Reference: OTGE00019054B

October 27, 2008

**Response to BGC Letter of September 5, 2008
Geotechnical Investigation
Arctic Bay Sewage Lagoon
Arctic Bay, Nunavut**

FIGURE 3-46 LONG-TERM COHESION OF FROZEN SOILS (Weaver and Morgenstern, 1981)

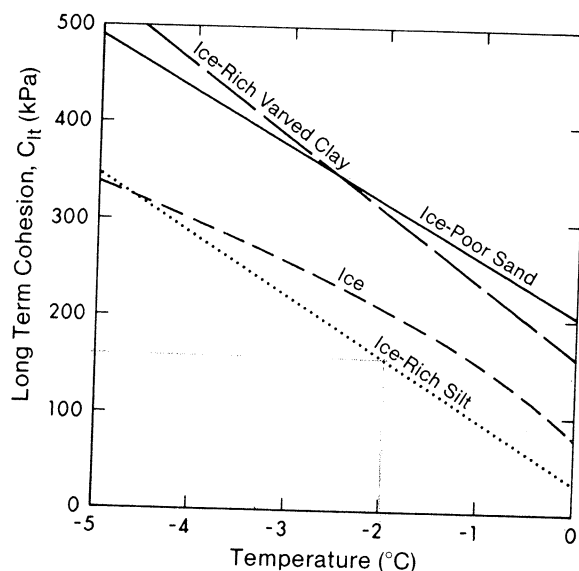
The reviewer also commented that the cohesion of the ice used in the slope stability analysis may be high. Attached herewith is Figure 3-46 Long Term Cohesion of Frozen Soils (Weaver and Morganstorm, 1981) from Cold Regions Utilities Memogram. It indicates that the cohesion of

the ice varies from approximately 90 kPa at 0°C to 340 kPa at -5°C. The cohesion value of ice used by Trow in the slope stability analysis was 100 kPa. Considering the concern expressed by the reviewer that the layer of ice is located close to the bottom of the active layer, it is possible that the temperature of the ice in the upper levels may rise to 0°C. Therefore, long term cohesion of ice of 90 kPa would be more appropriate.

Figure 5

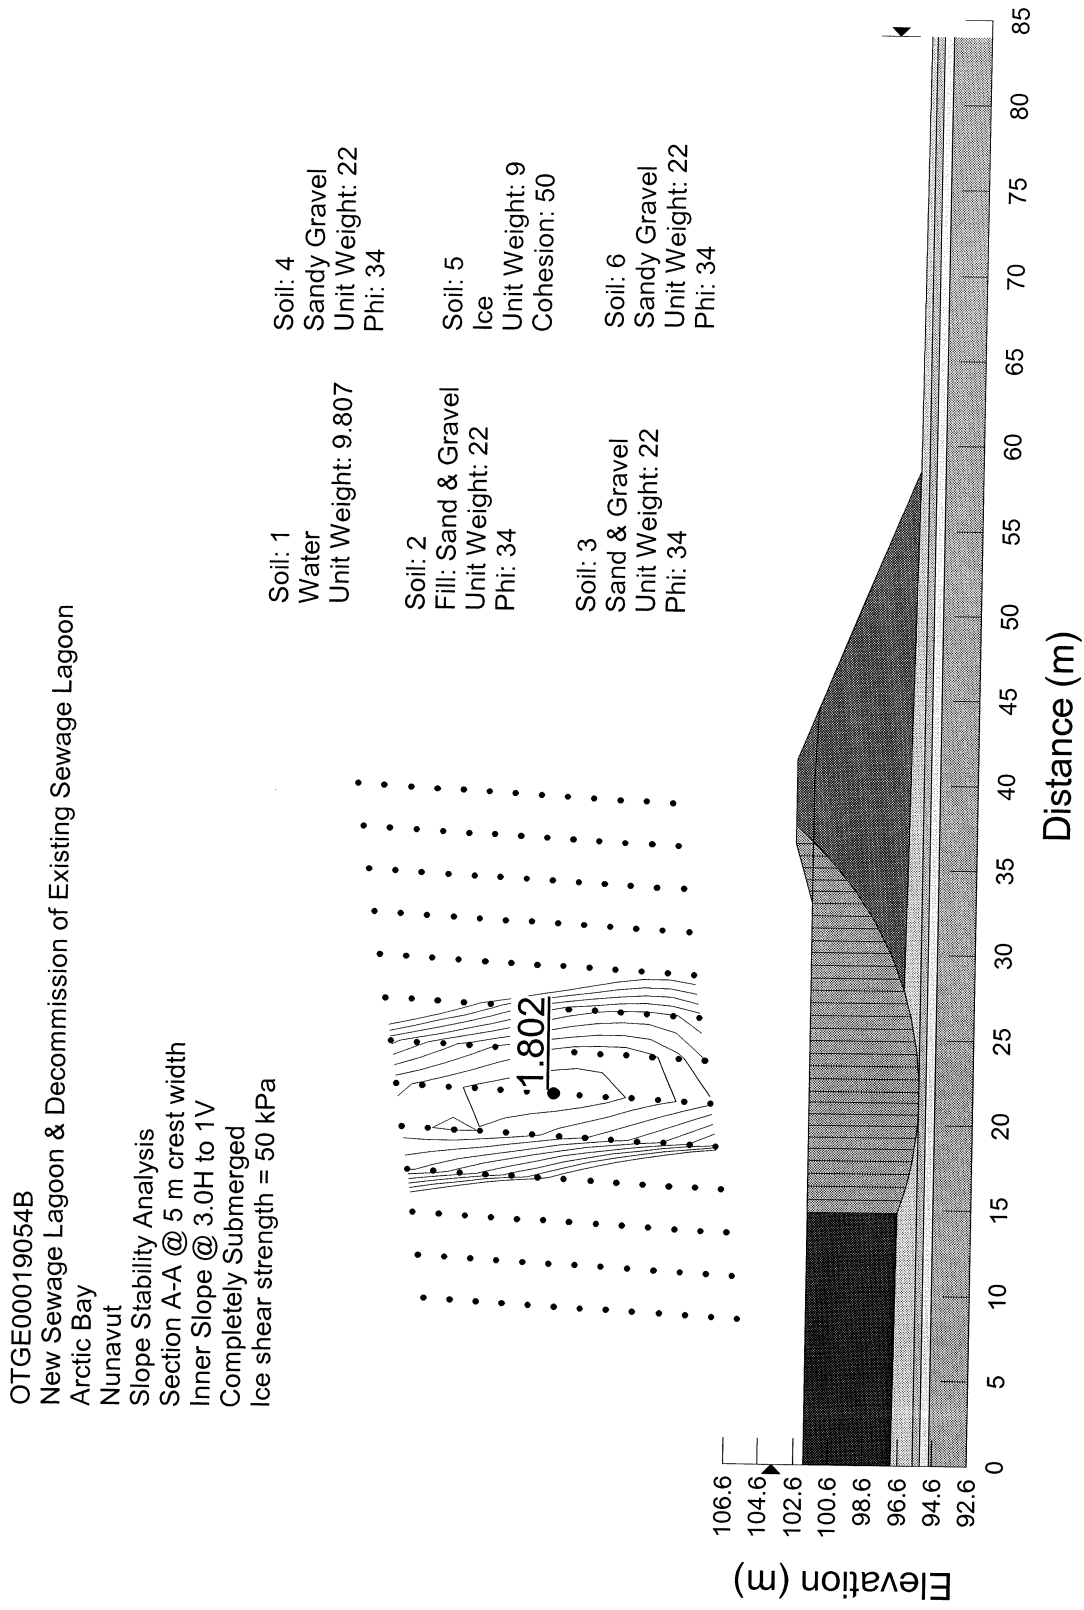
The reviewer had also commented that the critical failure surface may be at the interface of the overlying sand to gravelly sand and the layer of ice. In order to investigate this possibility, non circular slip surface analyses were performed. The cohesion of ice was assumed to be 50 kPa. The crest width was taken as 4 m with sloping stratigraphy.

A total of 8 non-circular slip surfaces were analysed for the most critical cases and have been summarized on Table I.

Section	Slope Identification	Slope Inclination	Loading Conditions	Computed Factor of Safety	Figure #
A-A	Upstream Slope	3H:1V	Lagoon drained. Water level in berms at Elevation 99.0 m	2.35	5
			Lagoon drained. Water level in berm at Elevation 99.0 m with seismic loading	1.97	6
	Downstream Slope	3H:1V	Steady state seepage	2.40	7
			Steady state seepage with seismic loading	2.0	8
B-B	Upstream Slope	3H:1V	Lagoon drained. Water level in berms at Elevation 99.0 m	4.1	9
			Lagoon drained. Water level in berms at Elevation 99.0 m with seismic loading.	3.12	10
	Downstream Slope		Steady state seepage	4.3	11
			Steady state seepage with seismic loading	3.65	12

A review of the above table indicates that factor of safety of 2.35 to 4.1 would be available for the static loading conditions and 1.97 to 3.65 for seismic loading conditions. These factors of safety are higher than computed for the corresponding cases assuming circular slip surface failures. It is therefore concluded that potential failure at the interface of the overburden and ice layer is not the critical failure.
